Illinois Power Company  
Clinton Power Station  
P.O. Box 678  
Clinton, IL 61727  
Tel 217 935-5623  
Fax 217 935-4632

November 3, 1995

Docket No. 50-461

Subject: Illinois Power's (IP's) Response to the NRC's  
Requests for Information Regarding Thermo-Lag

Figure 1

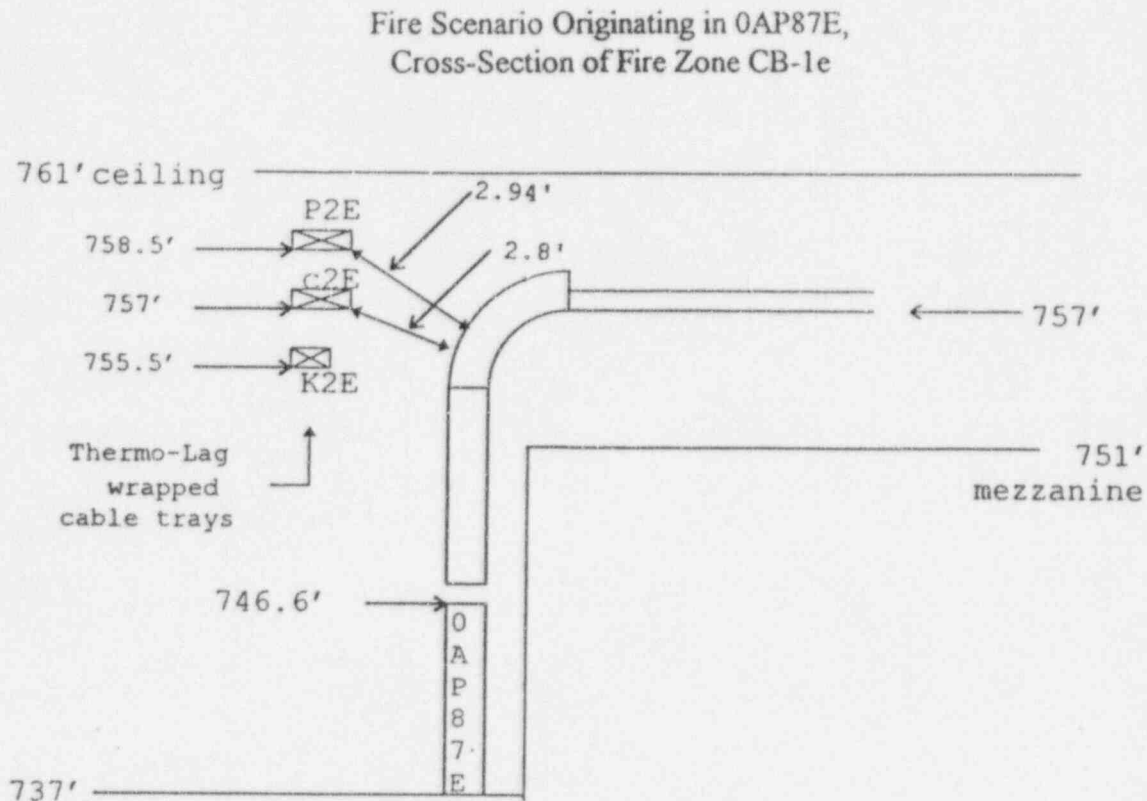
Conclusions stated by the licensee in the detailed justification for the deviation in this area are not technically supported. For example, the licensee stated that cable trays are all located high in this fire zone, therefore it is not credible to postulate cable damage from a fire at the floor level. This conclusion is not correct. It appears that the analysis only considers flame impingement as a credible initiator of cable damage, the licensee has not considered the rapid rise in temperature in the plume generated by a floor level fire, the high temperatures expected in the descending hot gas layer and the radiant energy transfer from these sources to the target cables, as sufficient to damage the cables. No basis has been provided to exclude these sources as potential initiators of cable damage. Provide the technical basis for excluding these sources for cable damage.

The licensee also concluded that a hot gas layer cannot be formed due to the use of conduit for cables not in trays, large distances between ignition sources and targets, and the use of IEEE-383 qualified cable. These considerations have little if any effect on the potential for the formation of a hot gas layer. The factors that affect the formation of the hot gas layer are the heat release rate of the fuel, fuel surface area, the compartment geometry and the compartment ventilation. Provide an analysis that considers all relevant factors in the formation of a hot gas layer.

The impact of a fire in 0AP87E was first examined by determining the location of 0AP87E in relation to the Thermo-Lag wrapped cables. No wrapped cables are located directly over the panel. Therefore, no impact from direct flame impingement or from the fire plume, other than heat up of the HGL, was possible. Figure 1 displays the potential fire scenario involving 0AP87E.

The impact of the ceiling jet generated by a fire in 0AP87E was also examined in the fire modeling analysis. The modeling of this fire scenario requires some judgment since the location of the fire moves until the fire is extinguished. The cable initially ignites at the top of 0AP87E (746.58 feet). The highest wrapped target near the cable riser is 2 feet below the ceiling and offset laterally approximately 3 feet from the riser.

In this scenario, the highest wrapped tray is initially partially within the ceiling jet sublayer. As the surface of the fire continues vertically, the tray quickly (within the first 1.08 feet of cable) fails to meet the 15% criteria for being affected by the ceiling jet sublayer. This movement of the fire surface is the major source of uncertainty in analyzing this scenario.

For those portions of the highest wrapped tray that are below the ceiling jet, no potential for damage to the tray from the jet exists. In this regard, the temperature of the ceiling jet at the highest point on the riser where the 15% criteria is met is only 193.9°F, well below any temperature where damage to electrical cables or Thermo-Lag could occur.

Fire Scenario Involving CC Pump  
Cross-Section of Fire Zone CB-1f

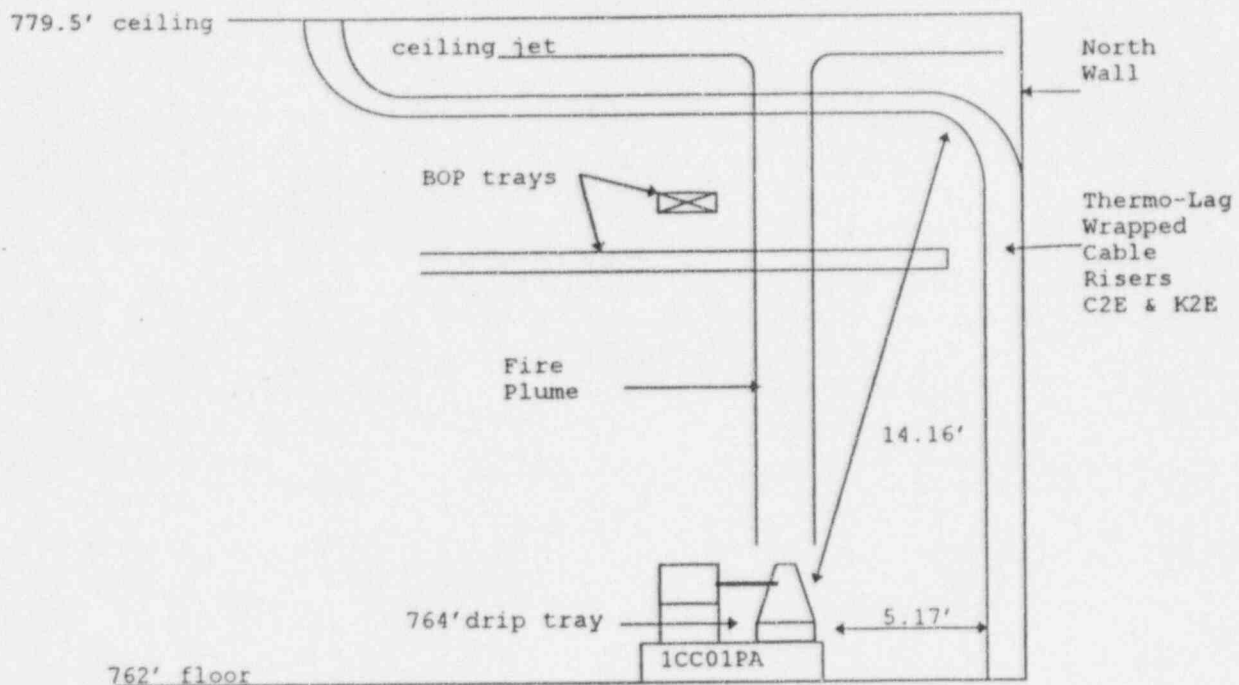
In this fire zone the licensee concluded that based on fire modeling there is no credible risk to safe shutdown equipment from either fixed or transient combustibles. The staff believes that the uncertainties associated with the use of fire modeling, due to the lack of experimental validation of the models for typical nuclear power plant compartments, and the lack of adequate data on the fire performance of components susceptible to fire damage typically present in a plant, make it unreasonable to conclude, based solely on the results of a fire model, that there is no credible risk of damage to redundant safe shutdown components from fixed and transient combustibles. Provide the detailed validation and verification of the fire model used in this analysis.

The CC pumps each have a drip tray located beneath the pump section of the pump-motor installation. These trays are rectangular with dimensions of 2.15 feet by 3.29 feet. Based on these dimensions a HRR of 954 BTU/s was calculated for oil fires originating from the CC pumps.

The wrapped horizontal trays make two 90° lateral bends and only pass over one of the CC pumps (1CC01PA) and are a minimum of 12.25 feet above the drip tray. While there are some intervening unwrapped cable trays, the location of these trays and their construction precludes cable ignition from occurring. With a Thermo-Lag ignition temperature of 1000°F and a HRR of 954 BTU/s, the wrapped trays would have to be within 8.7 feet of the surface of the fire for ignition to occur. This separation is also sufficient to prevent damage to the cables even without taking credit for the Thermo-Lag. Correspondingly, no potential impact from plume effects, other than heat up of the HGL, resulting from a CC pump oil fire exists.

The Thermo-Lag installation nearest the CC pumps is a vertical installation surrounding two cable risers and the overhead wrapped horizontal cable trays discussed above. The nearest CC pump drip tray (1CC01PA) is offset 5.17 feet from the vertical Thermo-Lag installation. Due to the proximity of this installation to 1CC01PA, the potential for ceiling jet or radiant energy exposure was examined. Figure 2 displays the fire scenario involving CC pump 1CC01PA and the vertical Thermo-Lag installation.

**#8 AWG, 1/C ampacity as a percentage of the IEIN 94-22 test result value for open tray**

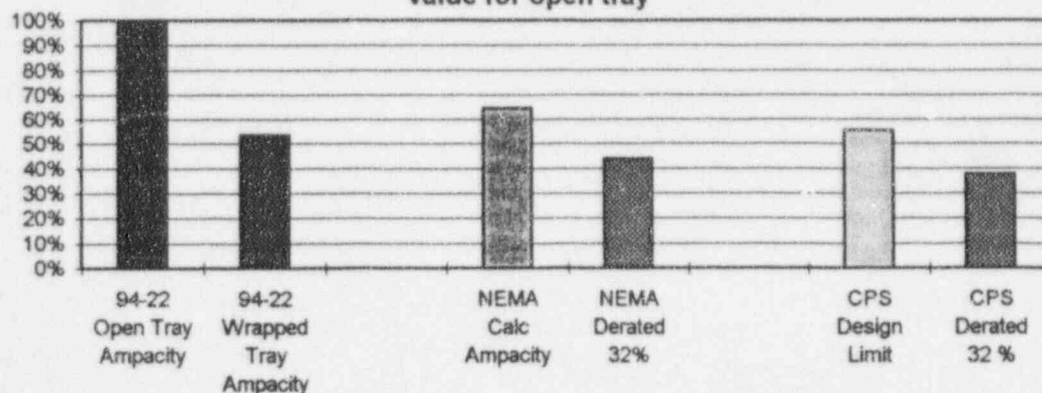
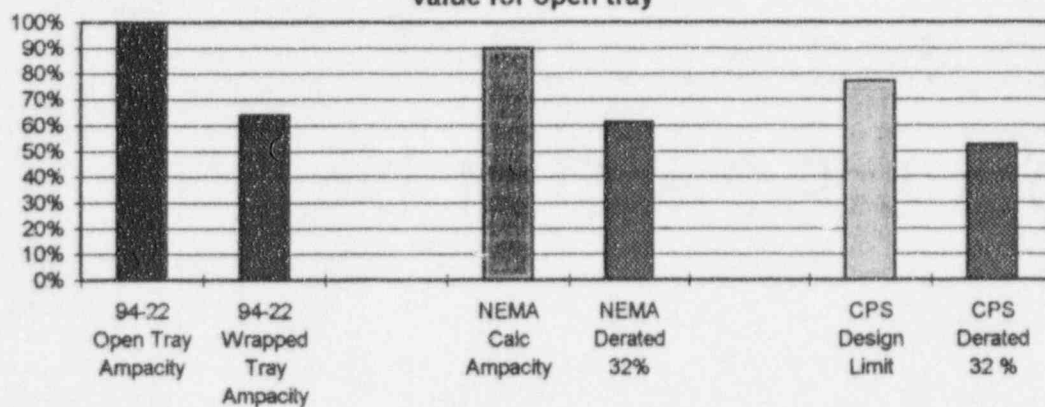
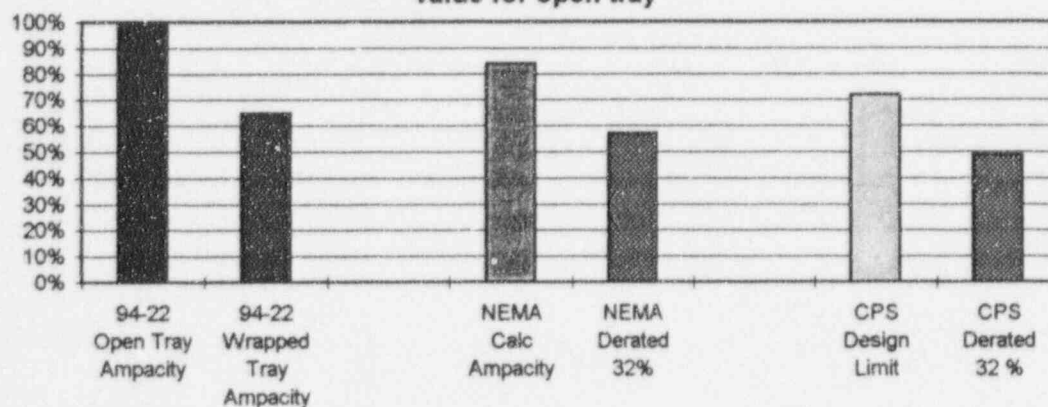
Given that there are no unresolved technical issues, the licensee is requested to provide its site-specific schedule and plans for the resolution of the ampacity derating issue for Thermo-Lag fire barriers.

As demonstrated by these charts, the derating factor at CPS (32%) is numerically smaller than the test value reported by the NRC in IEIN 94-22 (35%, 36%, and 46%). However, the charts also show that the actual ampacity values that would be allowed at CPS, both before and after derating, are significantly lower than the NRC values for the same cables. CPS's cables have substantial margin due to the utilization of a more conservative methodology.
